HISTORIC DISTRICT COMMISSION ADDITIONAL INFORMATION REQUEST

Date: 10/23/2025 Application Number: HDC2025-00655

APPLICANT & PROPERTY INFORMATION NAME: Blake I. Hattermann COMPANY NAME: BHattermann Architecture, LLC ADDRESS: 2010 Roseland Avenue CITY: Royal Oak STATE: MI ZIP: 48073 PROJECT ADDRESS: 1613 Leverette Street HISTORIC DISTRICT: Corktown

Response to staff report dated 10/07/2025

NEW ALLEY SIDE ELEVATION

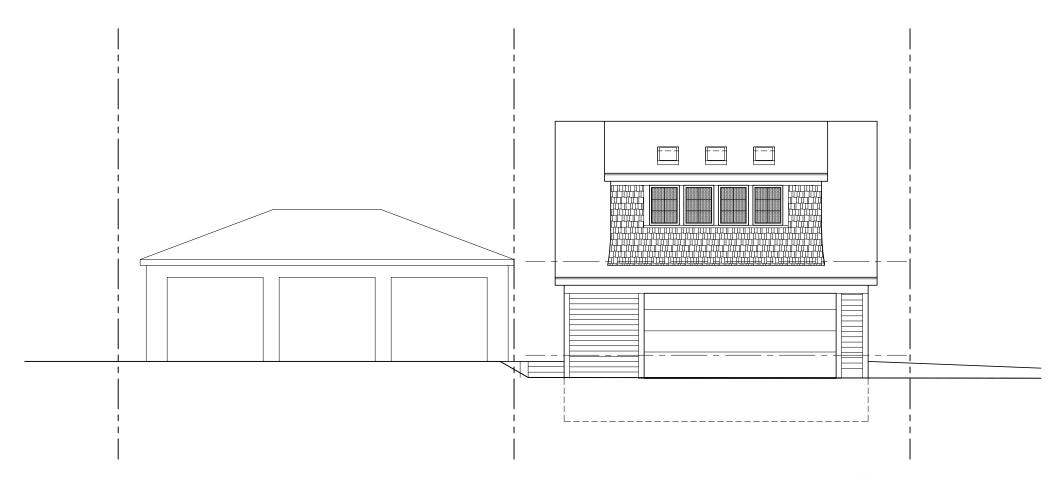
9.) New additions, exterior alterations, or related new construction shall not destroy historical materials that characterize the property. The new work shall be differentiated from the old and shall be compatible with the massing scale, size, scale, and architectural features to protect the historic integrity of the property and its environment.

In conjunction with the previous response, the new building was carefully designed and adopts design elements from the primary structure presenting a harmonious development that doesn't degrade the surrounding historic nature of the neighborhood. The use as a carriage house is present in many other examples the district, even at the end of the alley (1829 Leverette Street) where this project is located. In fact, 18.6% of the total structures located in the immediate districts are directly used as carriage houses, are attached garage structures (non-historic), or have massing similar to this project. It should be noted that a majority of the homes in the district do not presently have garages. This project has gone well above and beyond these existing examples to make the carriage house seem aesthetically historic in its design style.

Refer to attachments SK1-SK5.

- SK1 New and existing adjacent elevations.
- SK2 Existing elevations with new overlay (dashed)
- SK3 Existing elevations with new overlay (dashed)
- SK4 Map showing existing garages and carriage houses
- SK5 Photo examples of carriage house style structures in the district for comparison.
- SK6 Example of carriage house at 1829 Leverette at the end of the alley

racking of exterior wall

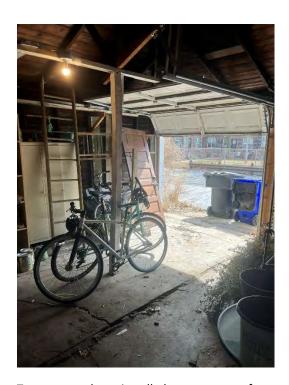
- The building is racking due foundation settlement and inadequate shear bracing.
- The roof structure is so badly deteriorated that it was required to be re-supported with a column disallowing use of one of the garage stalls.

The exterior walls require truing, and exercise of producing plumb walls. In addition, a system to provide shear resistance is critical. However, due to the age of the building, the infiltration of liquid water and water vapor, the likelihood of the fastening system of the studs and the exterior sheathing suffering from deterioration is eminent.

- Disassemble walls and discard sheathing
- Evaluate condition of framing members and discard deteriorated ones. Replace with new
- Rebuild new walls with shear system (panelized sheathing fastened per code)
- Add a top plate
- Replace sill plates with treated members

Interior concrete slab deterioration

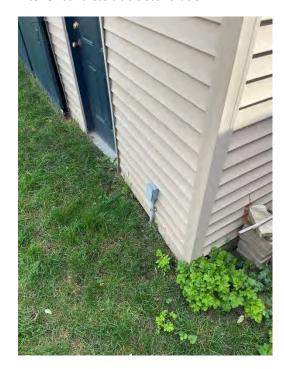
- Presently, the existing structure is so badly deteriorated that the foundation and slab have been compromised. The slab is severely cracked and heaving in places. The foundation settling and has a rodent infestation further weakening it (groundhogs).

- Remove slab
- Install new foundation to frost depth, min 42" below grade.
- The interior slab should be replaced and should rest on a minimum 6" compacted sub-base with a vapor barrier separating the slab from the sub-base.
- Raise height of slab above grade min 4".

Excessive deflection in supporting member

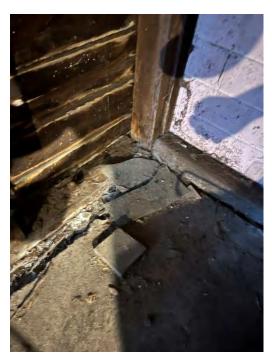
- The structural capacity of the roof is severely overstressed due to the member size and spacing and is sagging.
- The current configuration of the access point from the alley into the garage creates a hazard and has the potential to severely damage vehicles attempting to enter or exit.

Remove existing roof framing system, sheathing and roofing and discard. Or

- Add new framing members adjacent to and between existing ones to meet or exceed the code.
- Rebuild a new roof system with adequate framing members, sheathing and roofing
